Title of Change:	Change of cover tape for SOIC8L due to current cover tape discontinuance
Effective date:	15 Sep 2026
Contact information:	Contact your local onsemi Sales Office
Type of notification:	This Product Bulletin is for notification purposes only. onsemi will proceed with implementation of this change upon publication of this Product Bulletin.
Change Category:	Packaging
Change Sub-Category(s):	Shipping/Packaging/Marking

NEPTCO	UBoT	Remarks
Cover Tape Roll			Difference in color appearance (in roll)
Sample Photo (Empty Pocket)			UBoT cover tape is clearer compared tpo NEPCO

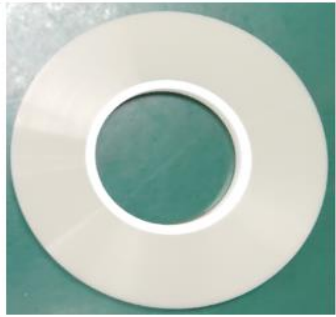
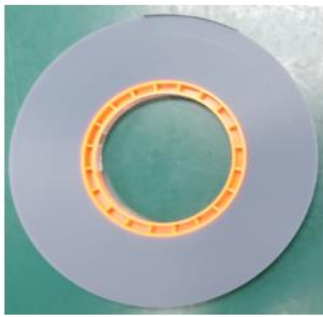
Current supplier NEPTCO of cover tape for SOIC8L at AMKOR has discontinued the product. To avoid supply disruption, onsemi is notifying customers of the change to new supplier UBoT.

There is no effect on the product or other packaging. The new cover tape is visibility slightly more transparent.
